Date: Thursday, October 30, 2014
Our ref: rs/ROL.14/1

**LAND AT R/O 101 BRECKNOCK ROAD
DAYLIGHT/SUNLIGHT REPORT**

Further to instructions received from our mutual Client, I have pleasure in addressing the points raised within the Local Authority's Statement of Case in respect of Planning Inspectorate Appeal referenced APP/X5210/W/15/3095453 with regard to the Planning Application 2014/5401/P. Specifically, I will address Reason 3 points 6.15 to 6.21.

WALDRAM ANALYSIS - REAR ELEVATION LEIGHTON PUBLIC HOUSE

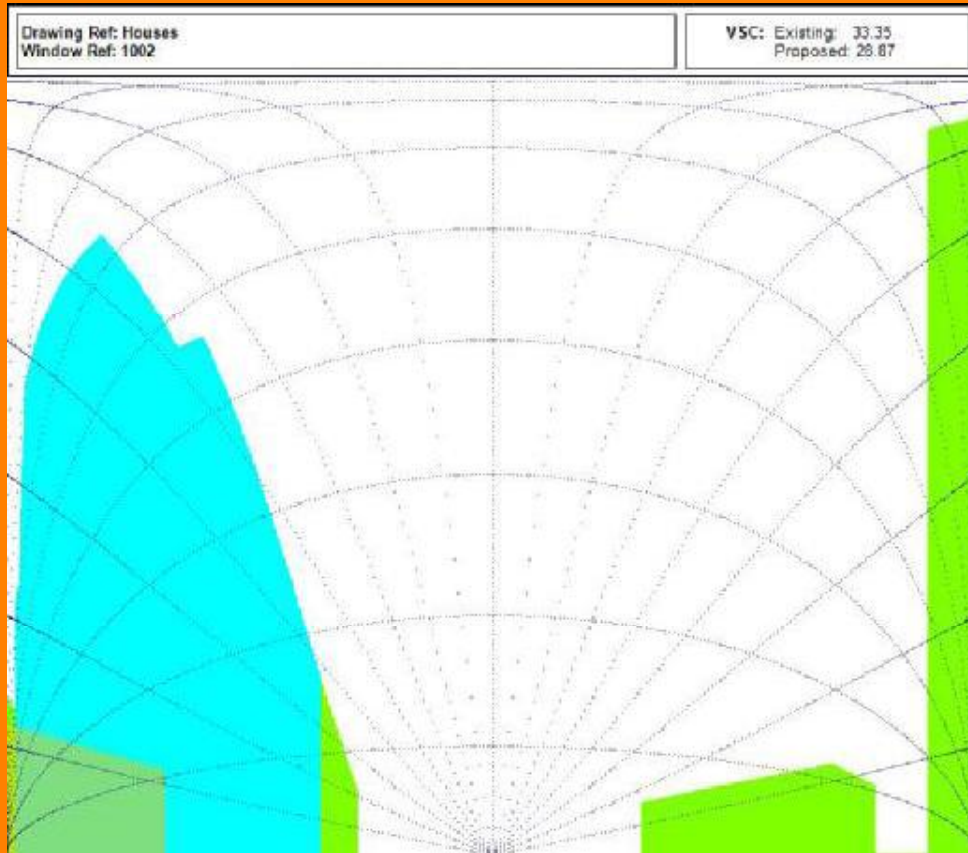
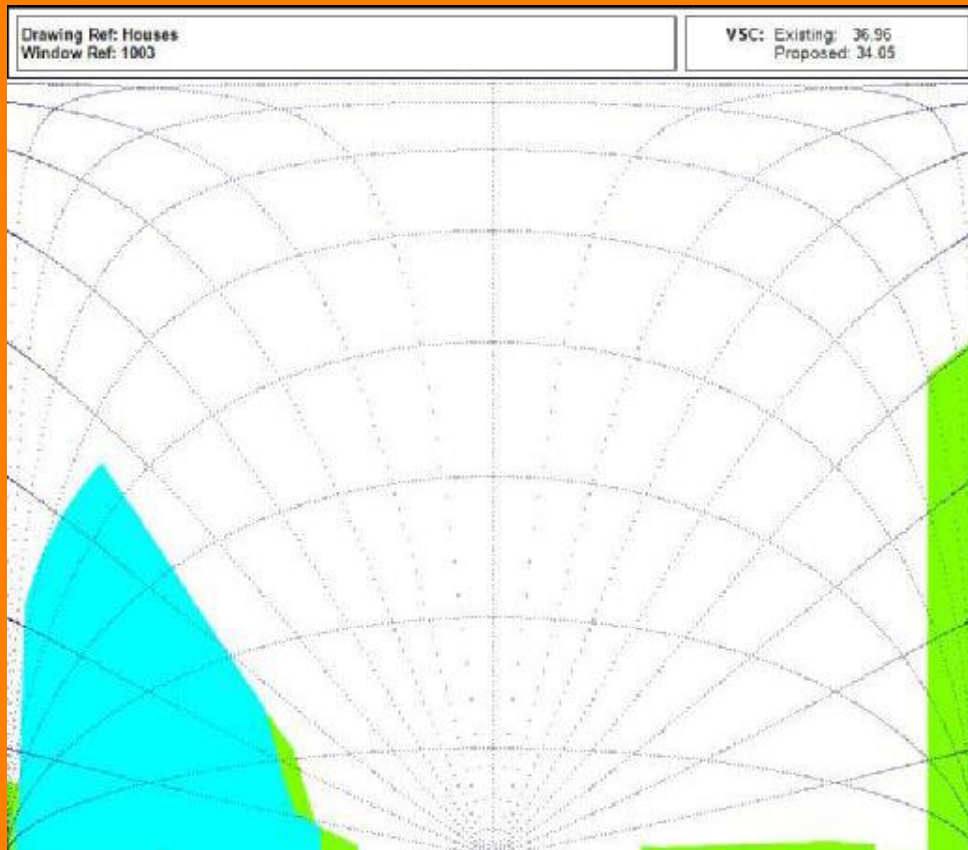
The attached Waldram diagrams - Reference 1002 Kitchen, Reference 1003 Bedroom, - demonstrate that having regard to daylight there will be a reduction of 4.5% VSC for the kitchen window and 2.93% VSC for the bedroom window.

In respect of sunlight, in the proposed condition, both windows will receive at least 25% of annual probable sunlight hours with at least 5% of winter probable sunlight hours.

Drawing Ref: Tortano Avenue
Window Ref: 1004

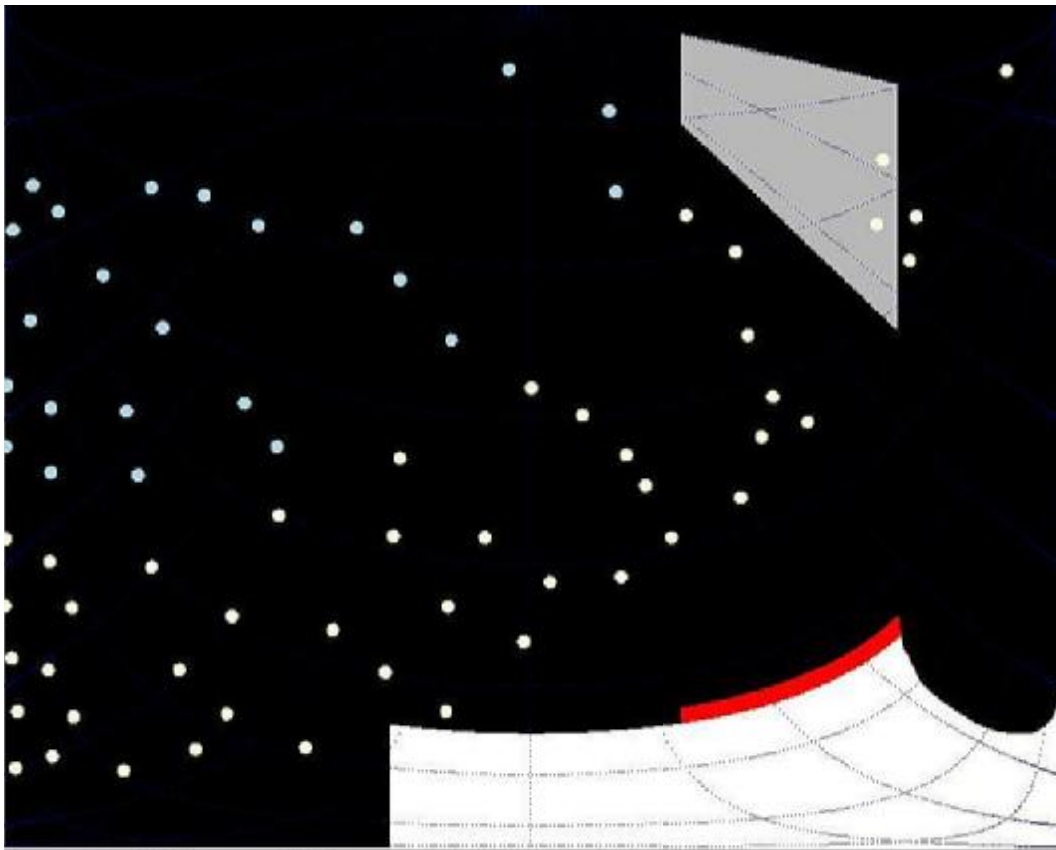
The Dixon Payne report states that the patio window only receives limited sunlight, but following the proposal would receive no direct sunlight
DP report indicates two windows (1003 and 1004) would see a reduction on VSC of more than 20% and that the patio window would see a reduction of VSC of 50%

With regard to windows 1003 & 1004, these are in a series of windows and, in accordance with paragraph 2.2.6 of the BRE Second Edition 2011 – '*If a room has two or more windows of equal size, the mean of the VSCs can be taken.*'. Using the figures for 1001, 1002, 1003 & 1004, the mean of the VSCs in the existing condition is 11.315% whereas in the proposed the mean is 9.2925%. This is a reduction of 0.8215 or less than 20% so the effect to these windows is indiscernible to the human eye and complies entirely with the aforementioned BRE Second Edition 2011.

NOTE BY MARTIN EVANS ARCHITECTS:
THIS IS THE PLANNING DRAWING OF
135 TORRIANO AVENUE AS PERMITTED

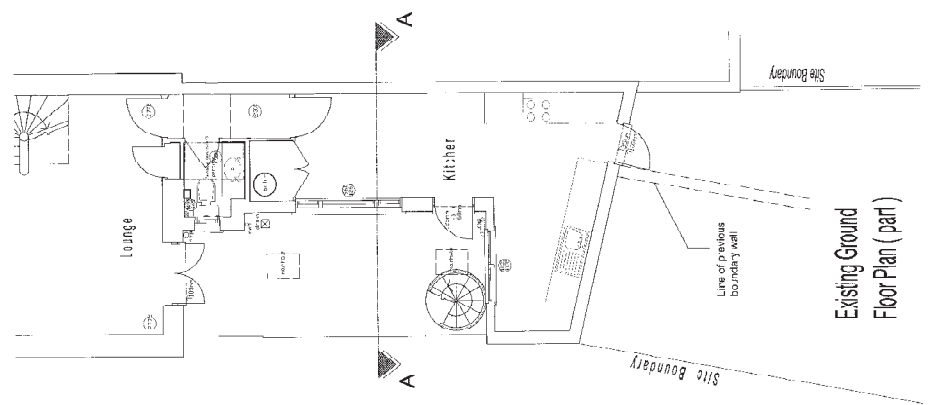
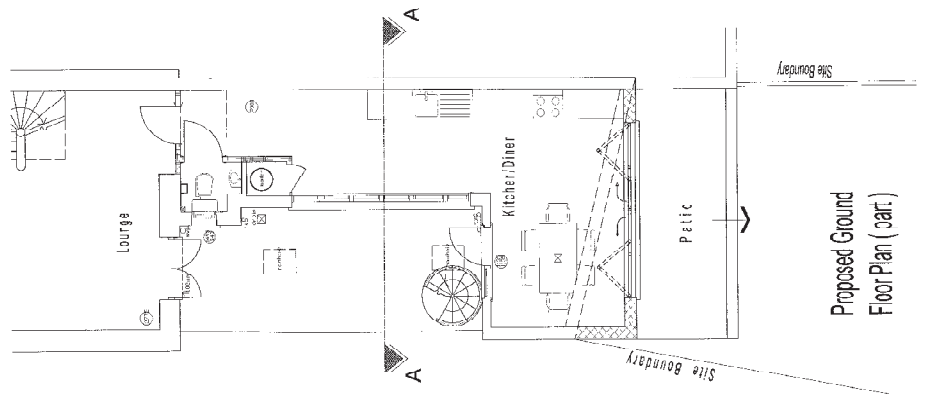
Attached is a drawing showing the proposed internal configuration of 135 Torriano Avenue, dated November 2013, which shows the proposal to extend the rear of the extension including the provision of rear fully glazed bi-folding doors opening onto a rear patio. The outlook of these windows is entirely unaffected by the Planning Permission Application works.

Within the Decision Notice, there is no reference made to these doors although the doors in their own right would provide sufficient internal illuminance.
